Vermont Agency of Transportation
RECEIVED
CK'D BY M.E.M OK'D BY C.W.M.
July 09, 2012
RESUBMIT APPROVED AS NOTED
BY C. CARLSON DATE 07-27-2012

PROJECT: VT RT 9, BRIDGE NO. 11
TOWN OF WOODFORD, VT
OVER WALOOMSAC RIVER

TITLE: CROSS FRAME

DRAWN BY	DATE	CONTRACT NO
BR	JULY 2012	UN04260
CHECKED BY GG	JULY 2012	DRAWING NO 107 A

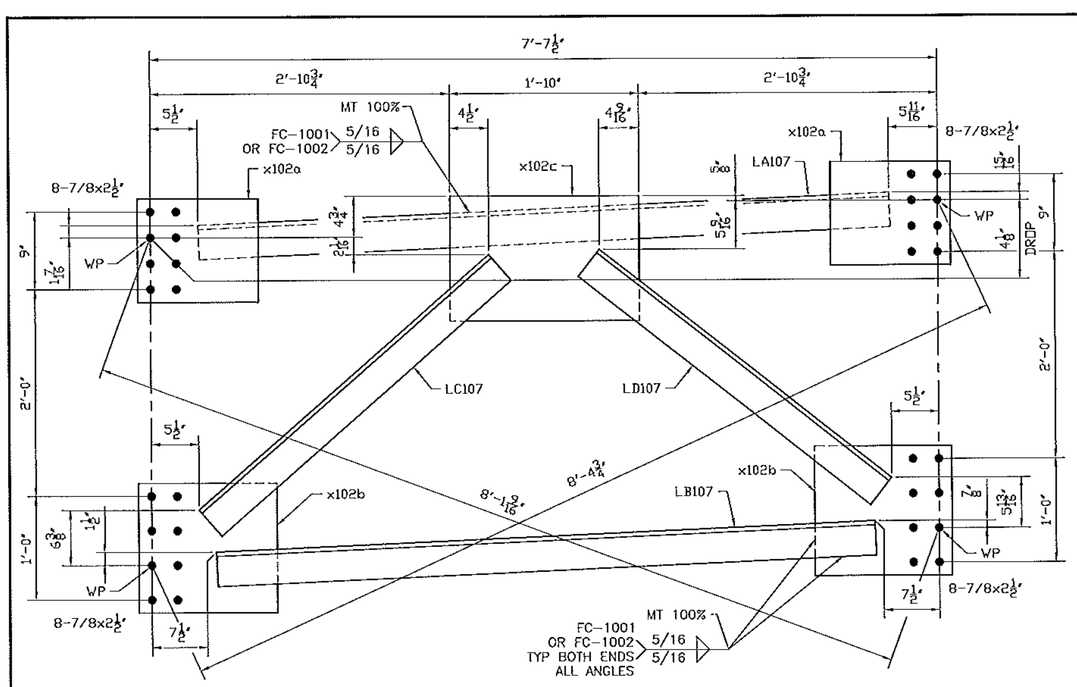
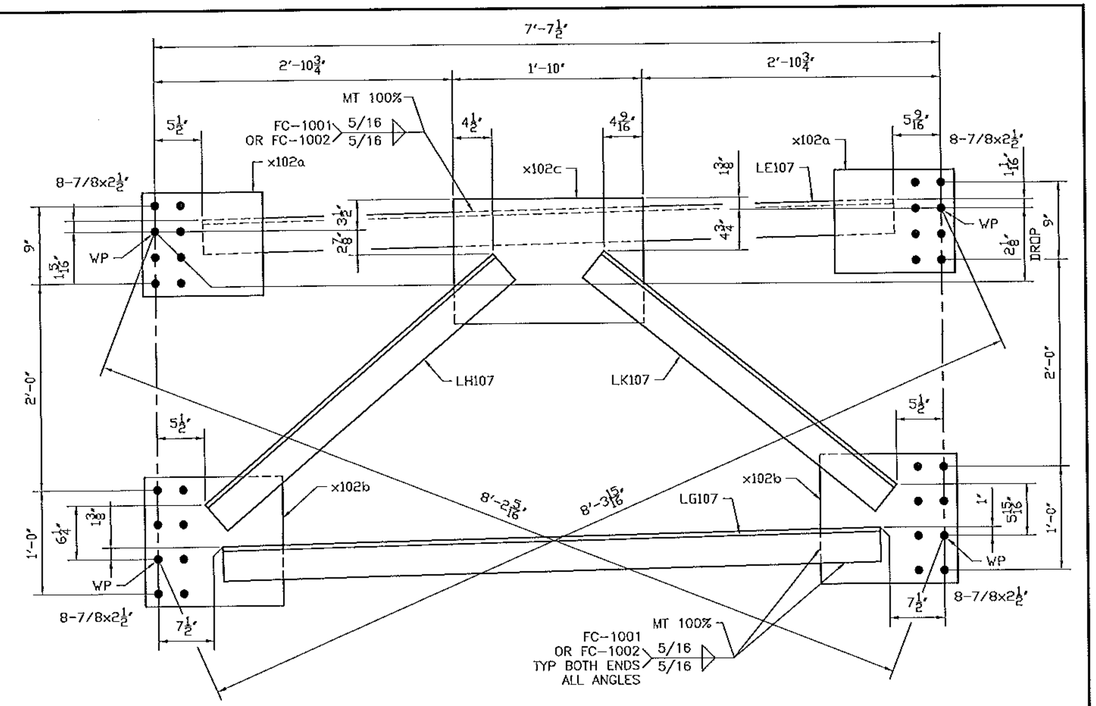
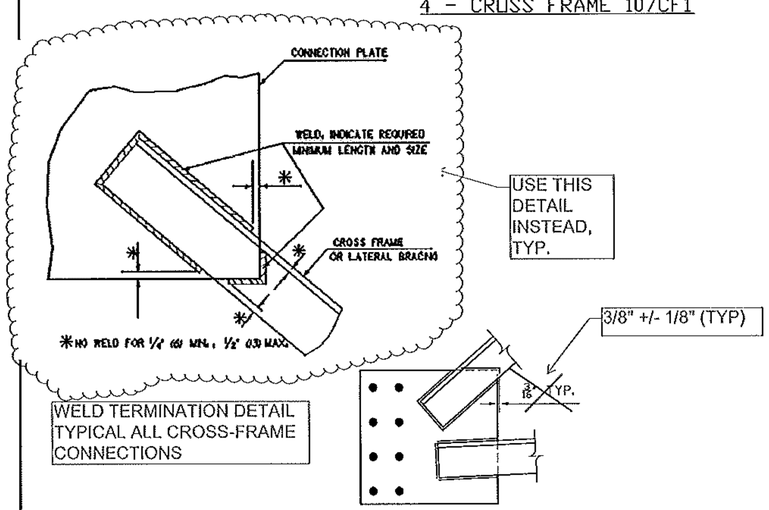
FB		FIELD_BOLTS							
78F212	128	.7/8 Dia A325 TYP3		2 1/2	1FL WASH		~~192~~

See standard specification 506.24(a)(9), no payment will be made for bolts, nuts, washers, they are considered to be incidental
